Planning Assessment Officer Report

PA2604395 – 161
McMahons Road, Frankston

Key Information	Details												
Application No:	PA2604395												
Received:	12 May 2026												
Applicant:													
Planning Scheme:	Frankston												
Land Address:	161 McMahons Road, Frankston (Lot 2 PS527651T)												
Proposal:	Development of a school building and business identification signage associated with an existing education centre.												
Development Value:	\$ 11,540,443												
Why is the Minister responsible?	In accordance with the schedule to Clause 72.01 of the Planning Scheme, the Minister for Planning is the responsible Authority for this application because: The development is associated with a non governmental school comprising a development with an <i>estimated cost of development is \$3 million or greater.</i>												
Why is a permit required?

Figure 1: Proposed site plan extract

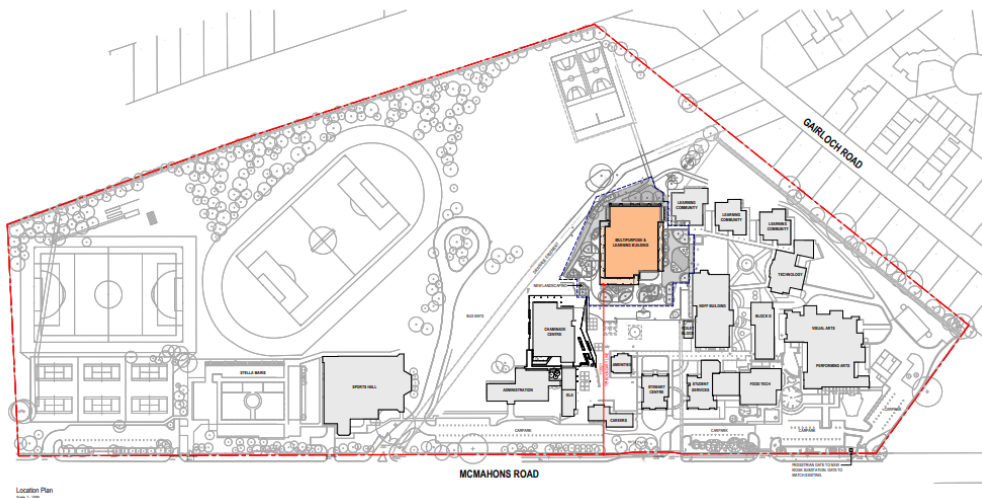
5. The proposed new building will comprise the following:
 - A gross floor area of 1,618m² and a maximum height of 10.356 metres.
 - A finished floor level of 11.61m AHD, providing at least 300mm freeboard above the applicable 1% AEP flood level.

60. The primary consideration from Melbourne water was that FFL are required to have a finished floor level of 11.61m AHD, providing at least 300mm freeboard above the applicable 1% AEP flood level. It is noted that plans demonstrate this compliance is achieved.
